Public Input No. 135-NFPA 780-2023 [Global Input]

Committee: LIG-AAA

Figure 4.5.2.2.2 Air Terminal Support.

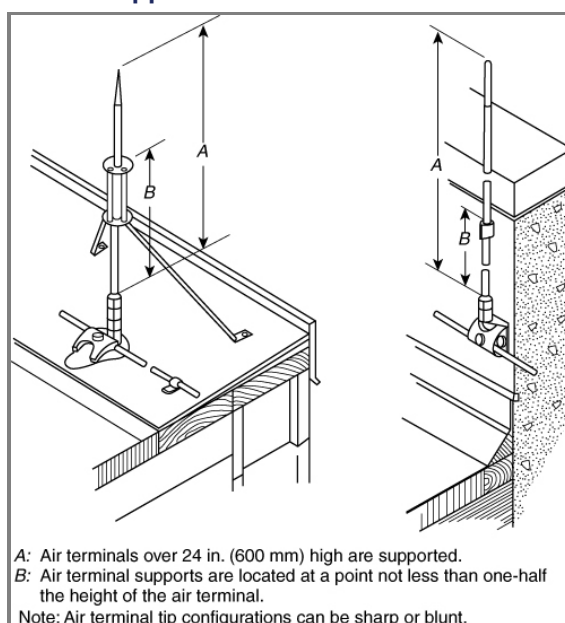
Air terminals exceeding 24 in. (600 mm) in height shall be ~~supported~~ braced at a point not less than one-half their height, as shown in Figure 4.5.2.2.2.

Resolution: It is difficult to verify or confirm wind loading or force on the unsupported air terminal.

Figure 8.3.2 Metallic (Faraday-Like) Cage.

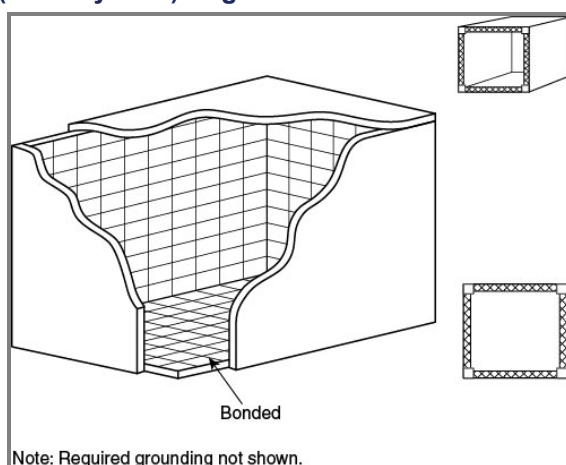
The only way to protect objects that are sensitive to electromagnetic coupling/inducing potentials, such as LEMP is to provide them with means of electromagnetic shielding. That's one reason why sensitive electronics are put in metal enclosures. Despite being connected to SPDs and being shielded from direct strikes, without a metal enclosure, which provides EM shielding, they would be exposed to external interference/inducing potentials including LEMP. Section 8.3.2 makes reference to some kind of EM shielding

Where optimum protection for structures housing explosives is required, such as protection from electromagnetic coupling or inducing potentials such as LEMP (as determined by the AHJ), a grounded, continuously conductive enclosure of adequate thickness, as shown in Figure 8.3.2, shall be used.

Figure A.11.1.1(a) Equipotential Method.

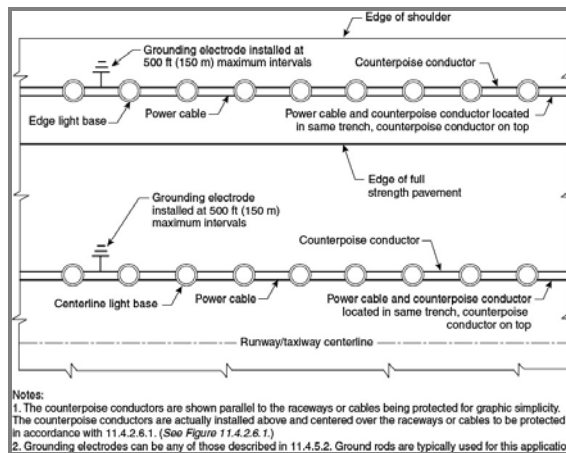
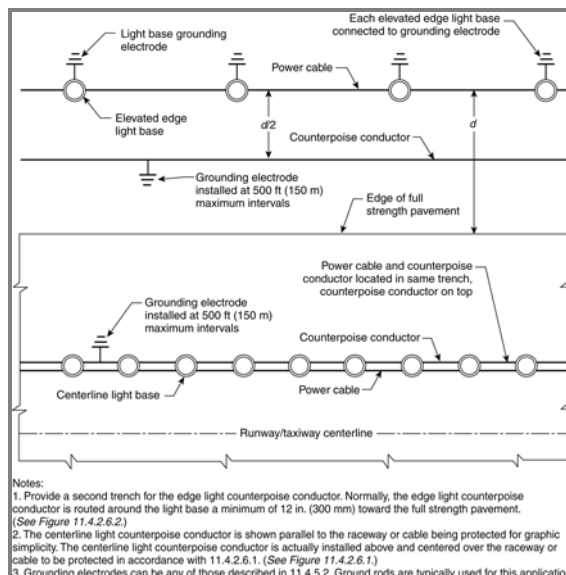
There are two generally accepted methods for providing lightning protection for airfield lighting circuits: equipotential and isolation. The equipotential method, which is described in 11.4.2.6.1, is shown in Figure A.11.1.1(a). The isolation method, which is described in 11.4.2.6.2, is shown in Figure A.11.1.1(b). The two methods should not be employed on a single circuit. The designer should select the installation method based on sound engineering practices and the success of the selected method in previous installations. An Equipotential lightning protection system is typically more economical to install and provides excellent protection from the effects of lightning in areas of high lightning flash density.

Provides cost input comparison for the engineer, AHJ and Owner. An equipotential method lightning protection system is more economical to install than a isolation method since the isolation method requires a separate trench for the counterpoise. Additionally, an additional grounding electrode is not required at each light base when using the equipotential method. The comment about quality of lightning protection was included so the reader would not imply that a more economical system would provide less protection.

Figure B.3.2.2 Lightning Protection Design Using the Rolling Sphere Method.

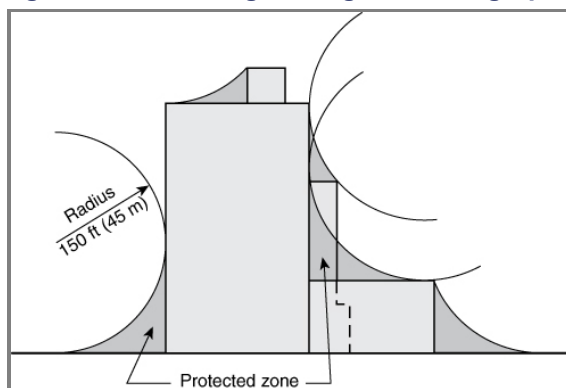
Where the RSM is applied to a building of height greater than the selected sphere radius, the sphere ~~touches the vertical edges~~ will touch vertical walls without protrusions on the sides of the building at all points above a height equal to the sphere radius. This indicates the possibility of strikes to the sides of the building and raises the question of the need for an air terminal network in these locations. Studies show that strikes to vertical edges on the sides of tall buildings do occur but are not very common. There are theoretical reasons for believing that

The revision proposes the deletion of the 5th paragraph as it is misleading and adds little to the discussion. The rolling sphere is a model used to determine the areas likely to provide an attachment point. There is no actual ball that rolls at a given velocity, constant or not. It has no dwell time, but instead has an increased “collection area.” This appears to be an observation from ZOP software and not particularly relevant to the physics of the process. The discussion should focus on the geometry of structure and concentration of electric field gradients if such a discussion is needed.

In the final paragraph, a revision is added to indicate that the discussion is relevant to flat vertical surfaces and can change if there are protrusions off the vertical surfaces. The revision at the end of the paragraph suggests that if an attachment to a vertical surface is of concern, a risk assessment should be performed to determine whether protection should be provided.

Figure L.2 2007–2016 Average 2 Average US Lightning Flash- Ground Strike Density Map (Flashes- Ground Strikes per Square Kilometer per Year). (Courtesy Vaisala, Inc.)

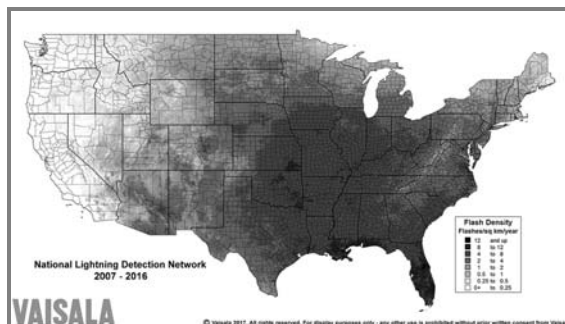
L.2 Lightning Flash- Ground Strike Density (N_{GSG}).

Lightning flash- ground strike density, the yearly number of flashes- strike points to ground per square kilometer, can be found in Figure L.2. A color version of this map with resolution of 2 km can be found at www.vaisala.com/en/products/data/data-sets/nldn.

Figure L.6.6.1.2 Collection Areas (A_D , A_M , A_L , A_{DJ} , A_I). (Source: IEC.)

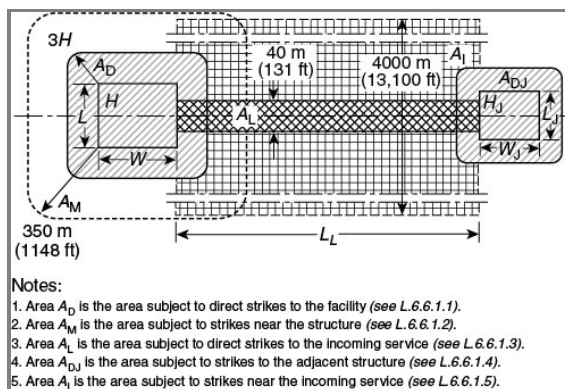
File Name	Description	Approved
Revised_Fig_L-6-6-1-2.jpg	Figure L.6.6.1.2

Replace figure with the revised L.6.6.1.2. Change NG in the equation to NSG.
